# **Response to Officer Comments**

**Land north and east of Tweed Lodge, Hoebridge East Road, Gattonside  
Scottish Borders**

**Erection of dwellinghouse**

**Application Ref. 22/00296/FUL  
Local Review Body Ref. 22/00030/RREF**

**25-degree - daylight**

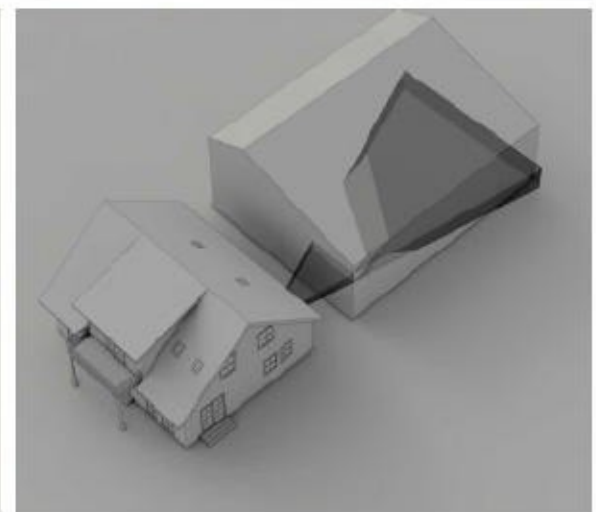
The Officer states that the Daylight Analysis Diagram does not overcome the Council's Supplementary Guidance and requirement for daylight to habitable rooms to be demonstrated via the '25 degree' rule. However, firstly, as noted above, the kitchen window in question forms a secondary light source into this space with the main daylight into the open plan kitchen and livingroom being achieved via the plentiful windows to south and east. The Supplementary Guidance refers to use of the 25 degree rule when a new building directly faces the window of an existing property, stating “suitable daylight for habitable (principle) rooms is achieved when a 25 degree vertical angle taken from the centre of the lowest window is kept unobstructed”. The kitchen window is not the main light source and it is considered that daylight into the 'principle' habitable space is addressed via the design of Tweed Lodge with windows to south and east.

The applicant was not informed of any supposed deficiency in this respect during lengthy application discussions (where a number of design changes were requested and provided). The daylight diagram demonstrates that it is still possible to achieve good daylighting, providing the obstruction is not continuous, which is the case with the proposed house which has single and two storey elements. This is illustrated in the diagrams below showing the rule applied to the barn that occupied the site and then the proposed house.

The area of construction within the 25-degree projection is illustrated in these diagrams. The volume is taken from the centre to the top of the window in question and drawn towards the metal shed building.
